project **Stanwell New Projects Office**
Switchyard Road,
Stanwell, QLD, 4702

title **Section Details - Facade - Entries**

title Plan Details - Facade

1.2.4 DOCUMENT REVIEW The reviewer shall review the documents submitted by the contractor to ensure that they are complete and accurate. The reviewer shall also ensure that the documents are in accordance with the contract requirements. The reviewer shall provide a written report of the review to the contractor within the specified time frame.	
A Reviewed by Contractor	B Reviewed by Consultant
C Reviewed by Employer	D Reviewed by Architect
Normal Kesejahteraan Date: 17/12/2025	
 Inhabiti Inhabiti Australia Pty Ltd

7 Row 2 Flashing Detail
1 : 5 Typ. Window Head

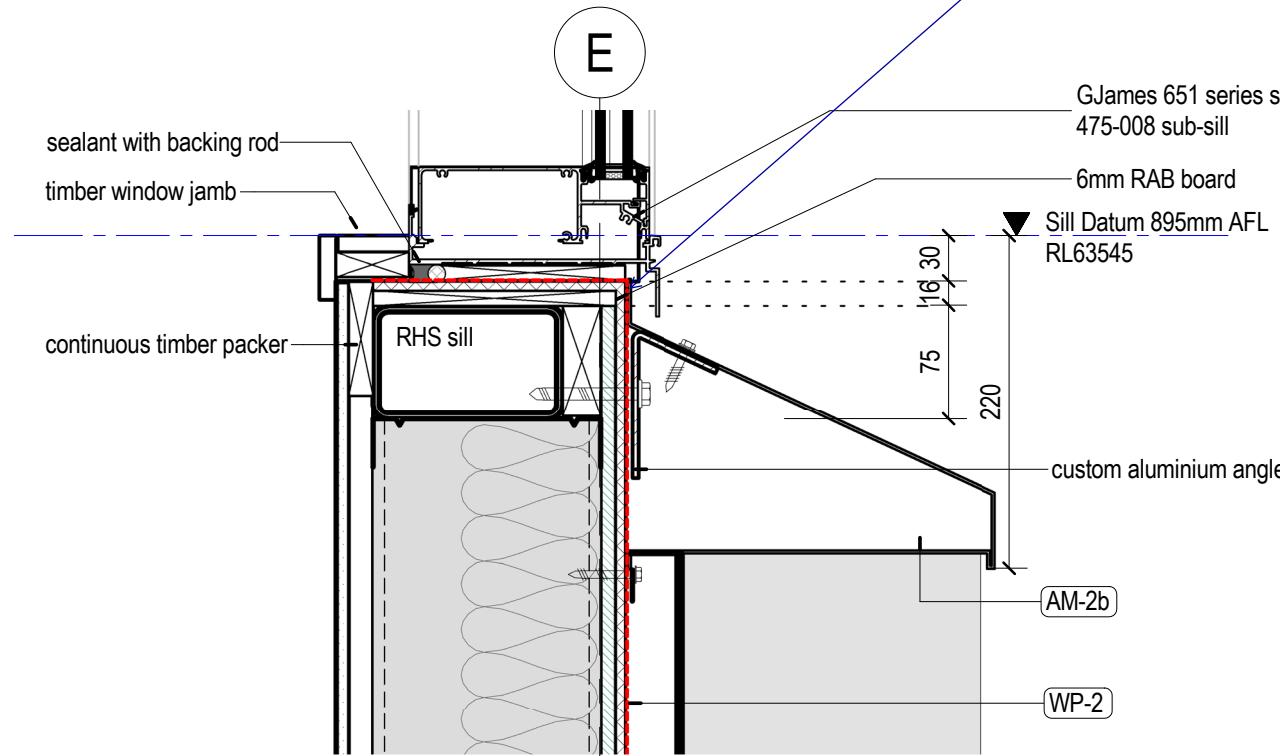
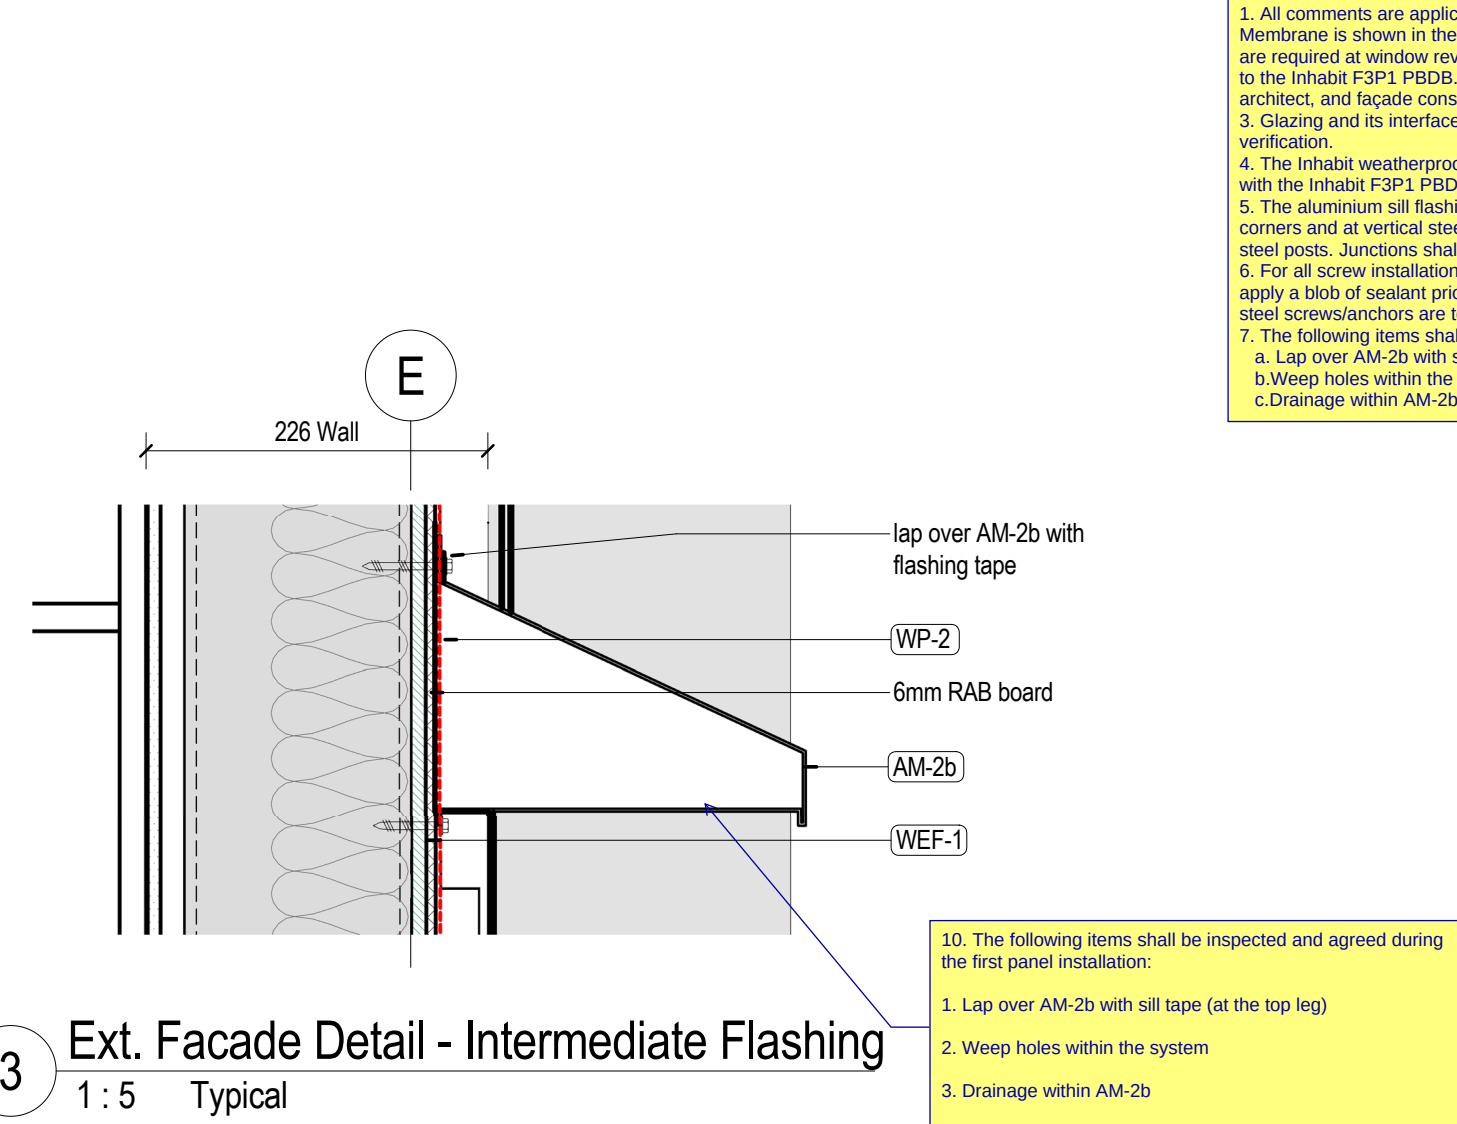
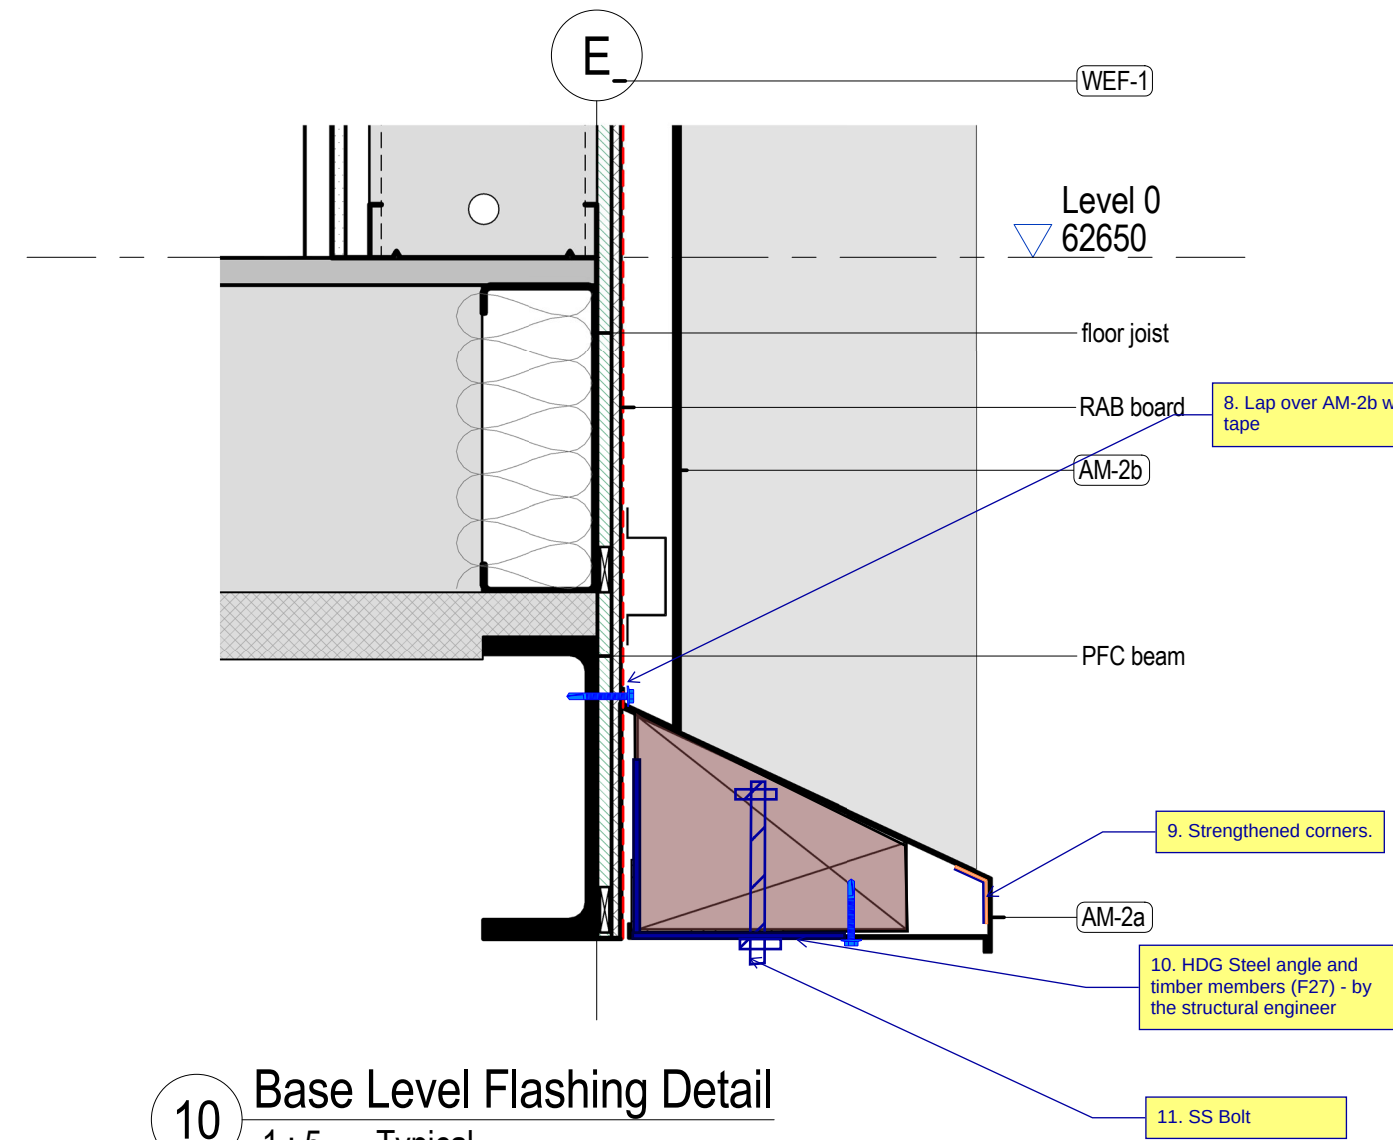
Notes:
1. All comments are applicable to similar details.
2. Membrane is shown in the architectural facade drawings below, however, specialised membranes are required at window reveals, including window sills, lap joints, and membrane terminations. Refer to the Inhabit F&P1 PBD8. Where information is not available, liaise with the product supplier, architect, and facade consultant.

3. Glazing and its interface details need to be reviewed as part of the shop drawings for FP1.4 verification.
4. The inhabit weatherproofing mark-ups on the architectural drawings are to be read in conjunction with the Inhabit F&P1 PBD8.

5. The aluminium sill flashing shall be installed with end dams at each end and fully sealed at corners and at vertical steel post interfaces. The flashing shall be continuous and wrap around the steel posts. Junctions shall be verified by water hose testing.

6. For all screw installations between the timber/aluminium-framed cladding and the substrate, apply a blob of sealant prior to installing the screw, and seal the screw heads afterwards. Stainless steel screws/anchors are to be used.

7. The following items shall be inspected and agreed during the first panel installation:
a. Lap over AM-2b with sill tape (at the top leg)
b. Weep holes within the system

c. Drainage within AM-2b
